INCH-POUND
MIL-PRF-123B
AMENDMENT 4
21 May 1997
SUPERSEDING
AMENDMENT 3
4 January 1995

PERFORMANCE SPECIFICATION

CAPACITORS, FIXED, CERAMIC DIELECTRIC,
(TEMPERATURE STABLE AND GENERAL PURPOSE), HIGH RELIABILITY,
GENERAL SPECIFICATION FOR

This amendment forms a part of MIL-C-123B, dated 6 August 1990, and is approved for use by all Departments and Agencies of the Department of Defense.

Example 6 "

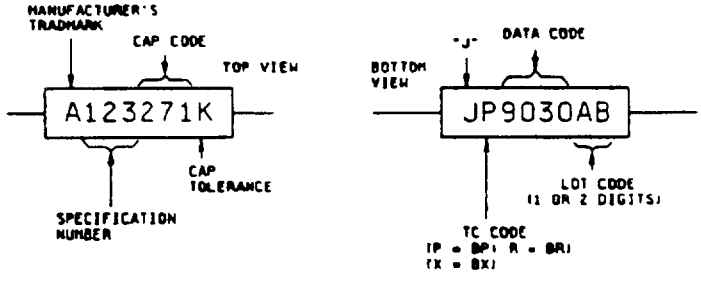
FIGURE 3, example 6, delete and substitute:

FIGURE C-7. Chip-outs. "

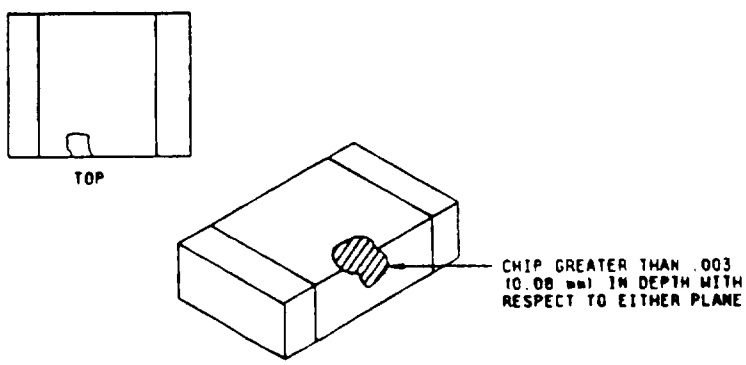
FIGURE C-7, delete and substitute:

30.2.2.d, first sentence, delete and substitute:

"Edge chip-outs shall not be greater in depth than .003 inch (0.08 mm) with respect to either plane."

FIGURE D-1. Lead-pull direction"

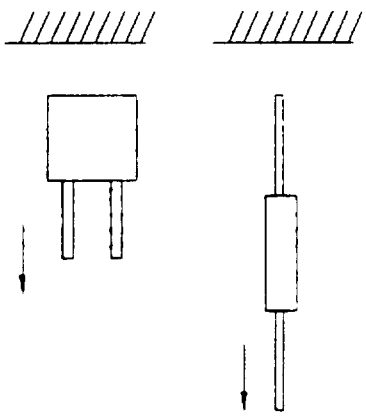
FIGURE D-1, delete and substitute:

"40.2 Axial devices. Firmly clamp both leads into the test fixture. Gradually apply an increasing force (see figure D-1) until the limits specified in table XIV are exceeded."
